Johnson & Sedlack

June 15, 2015

Re: Valiano Specific Plan, SCH NO. 2013061042—Public Comments on Draft Environmental Impact Report

The following comments are submitted on behalf of the Elfin Forest Harmony Grove Town Council regarding the Draft Environmental Impact Report (DEIR) for the Valiano Specific Plan Project.

VALIANO
RPO BUFFERS AND FUEL
MODIFICATION ZONES
SHEET 5 OF 6
AUGUST 8, 2014

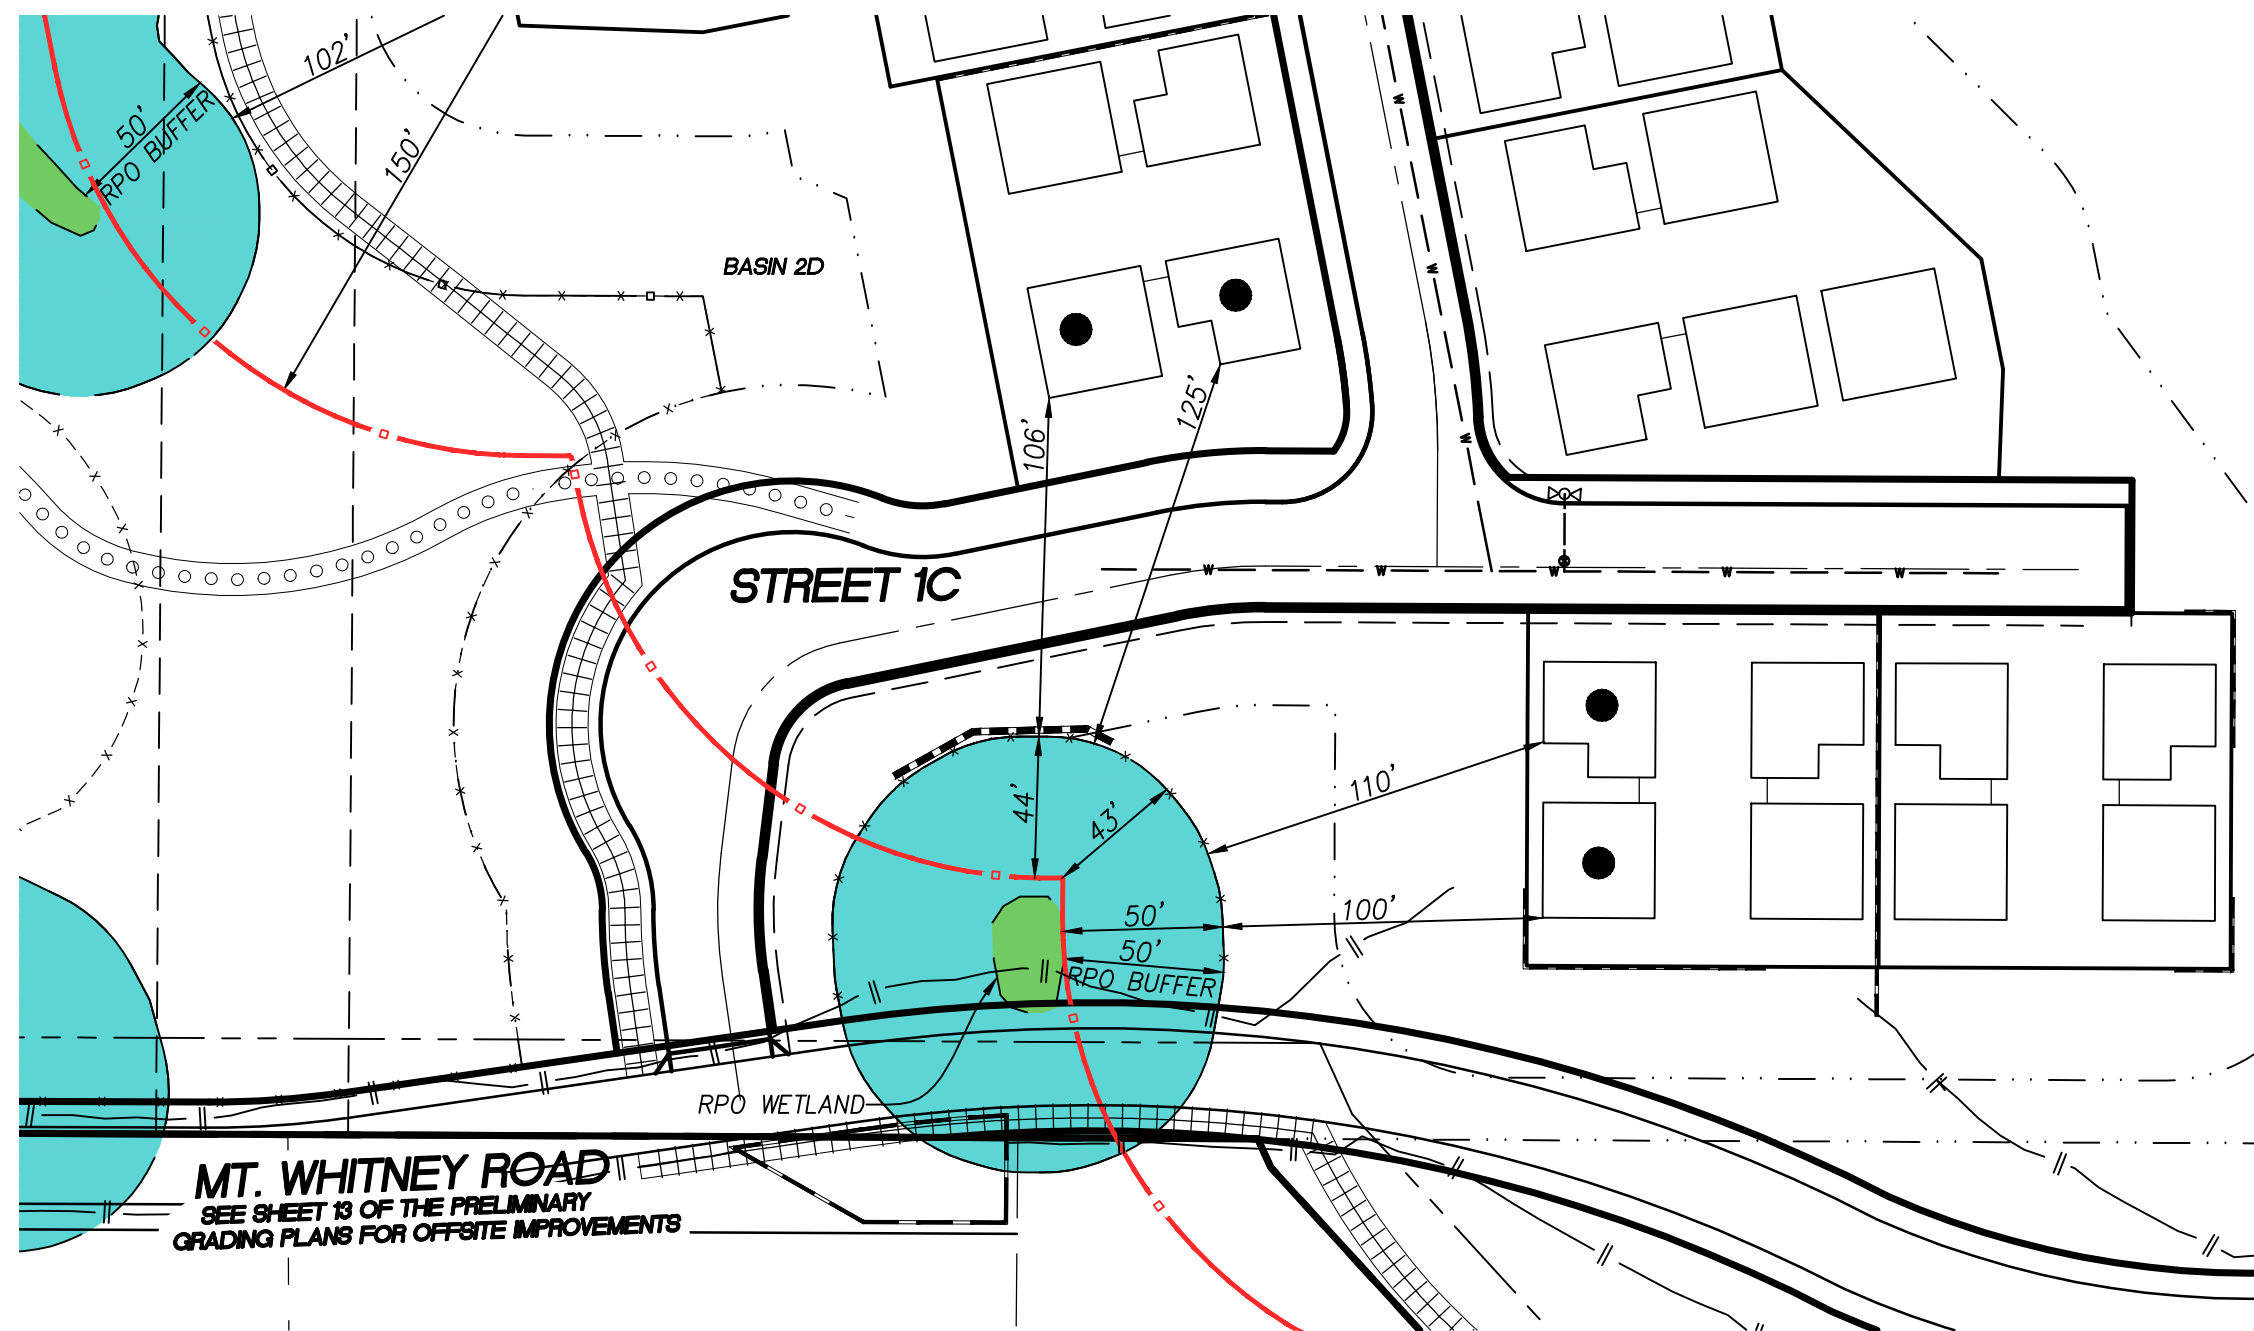
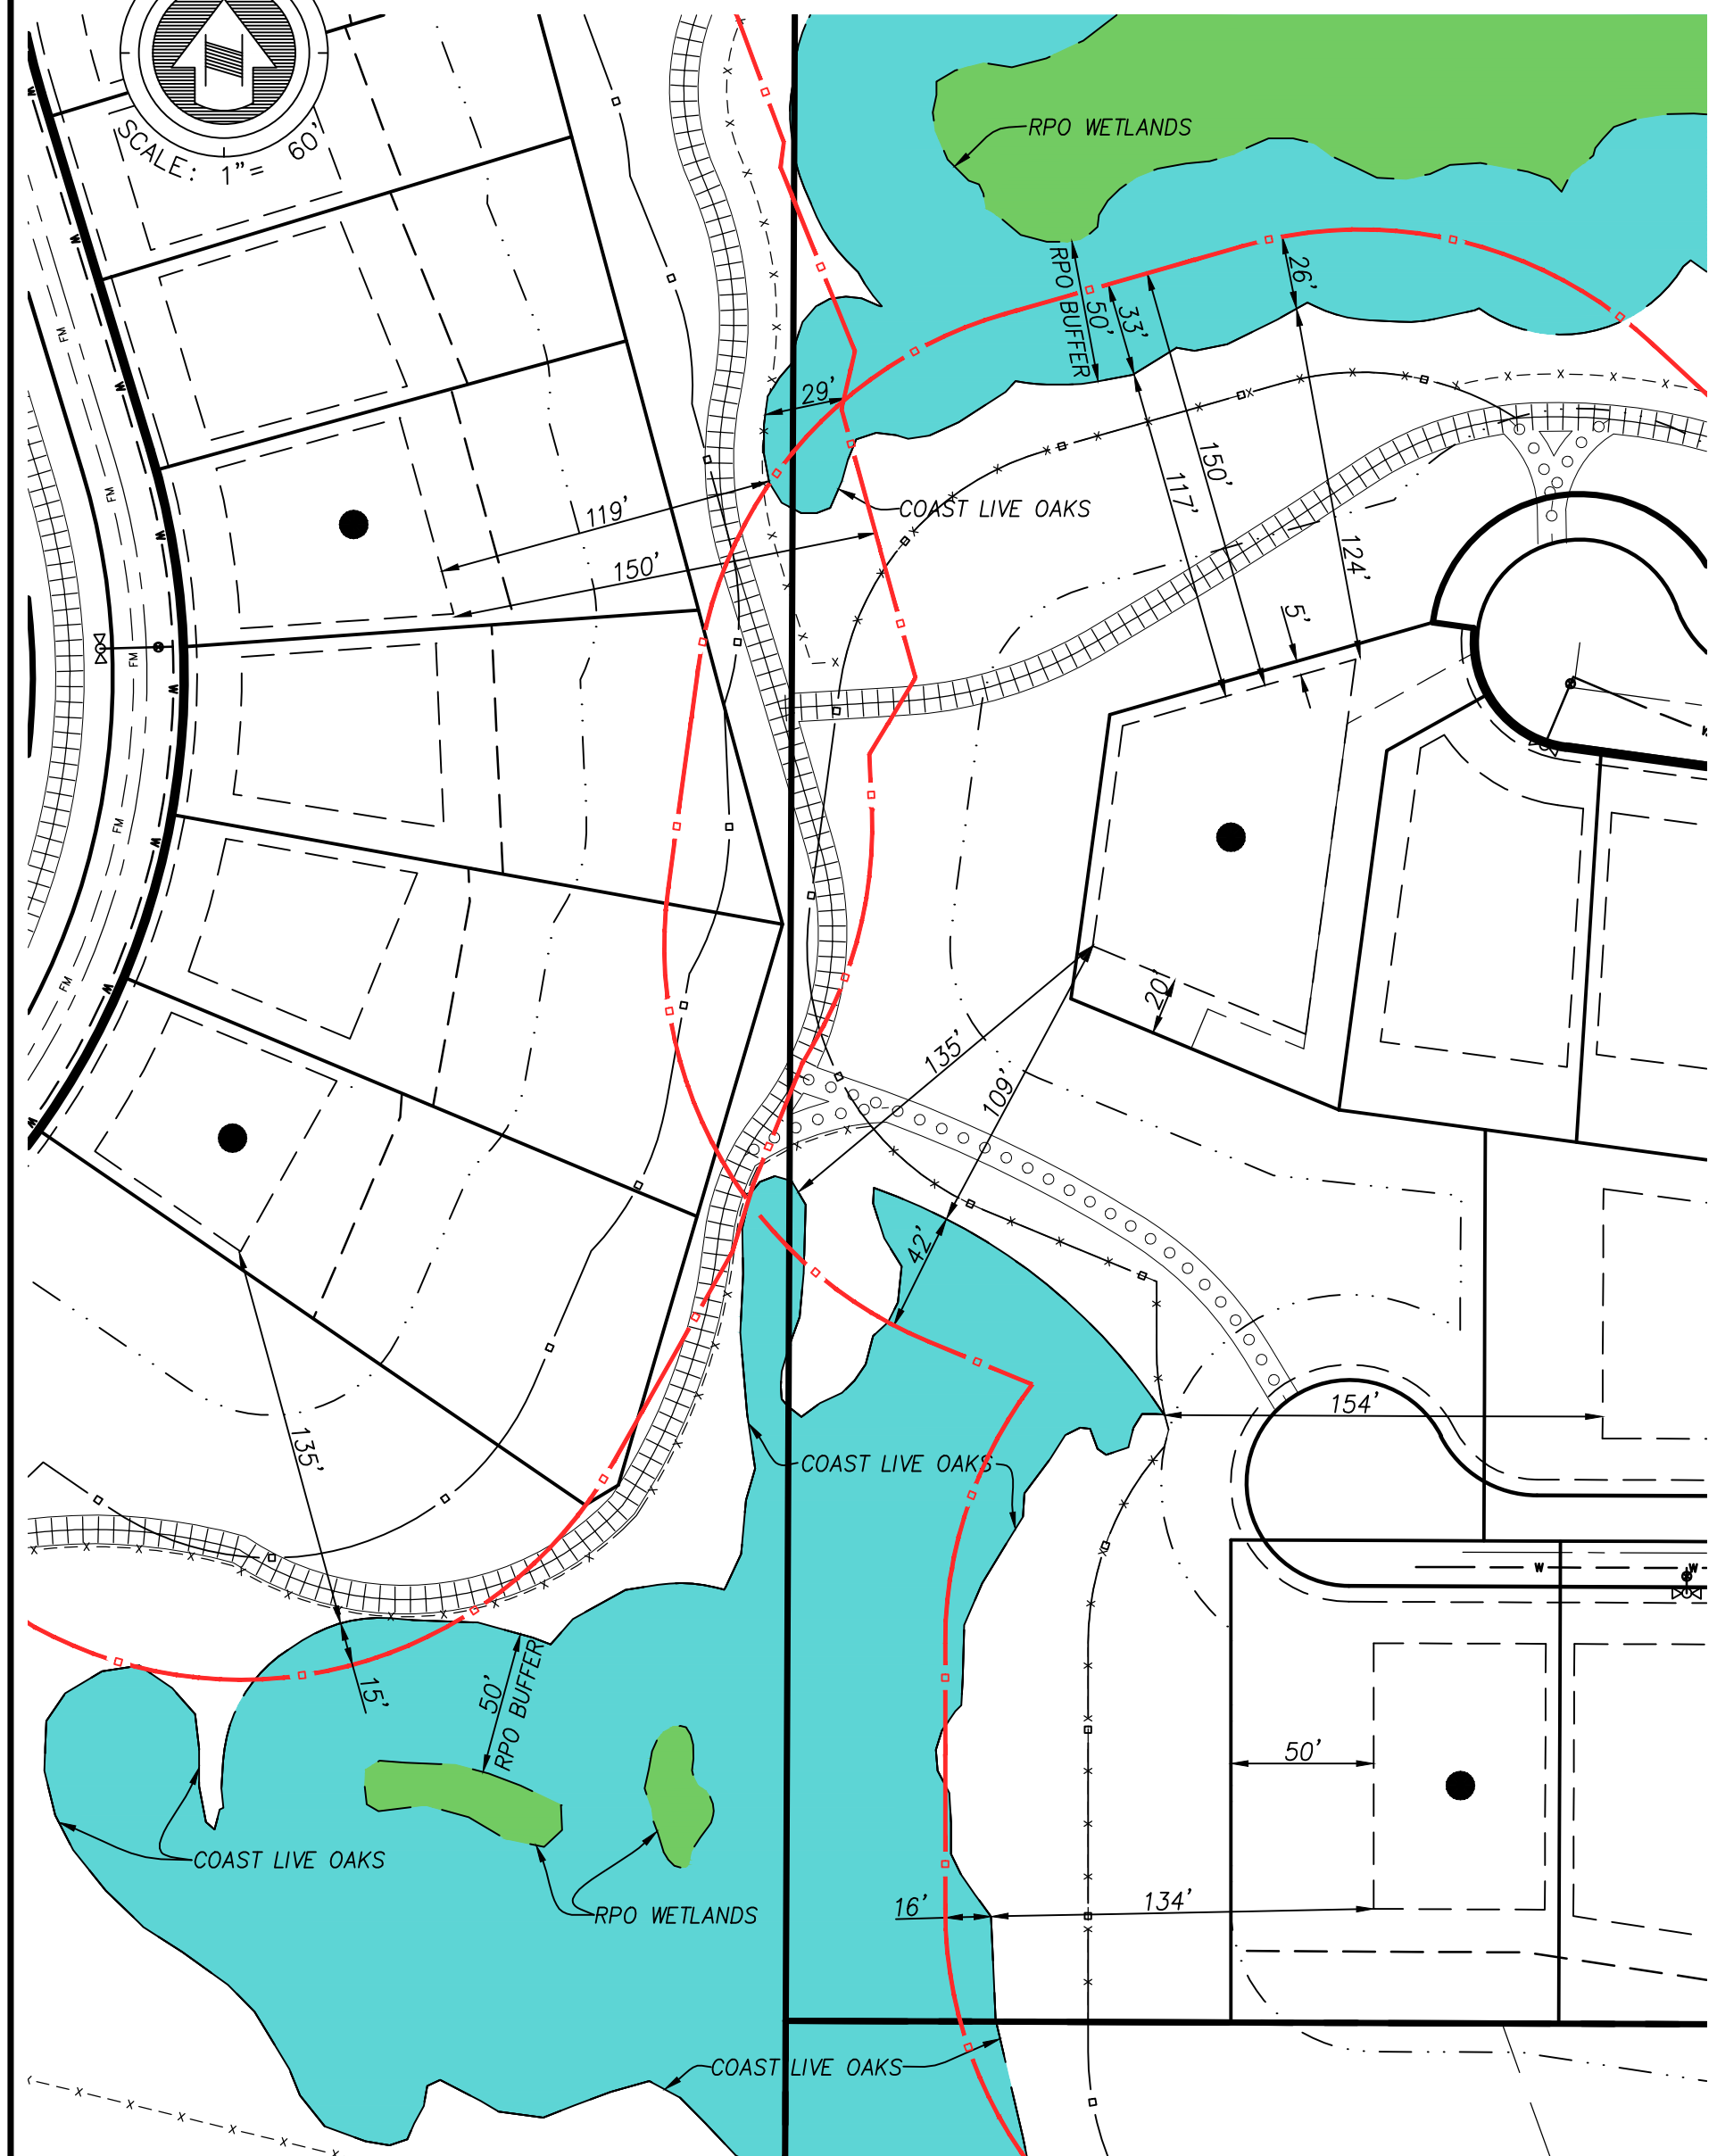
- Do FMZs overlap with areas required for biological mitigation? *See*, attached **Exhibit B** (August 14, 2014 site drawings)
- Section 4.5.3 of Appendix L states regarding Zone 3 (the off-site perimeter parcels which provide the required 150-foot fuel treatment zone for select Project parcels) that adjacent properties will provide the required modification of hazardous fuels 150 feet from off-site structures. There is no assurance that easements can be obtained.
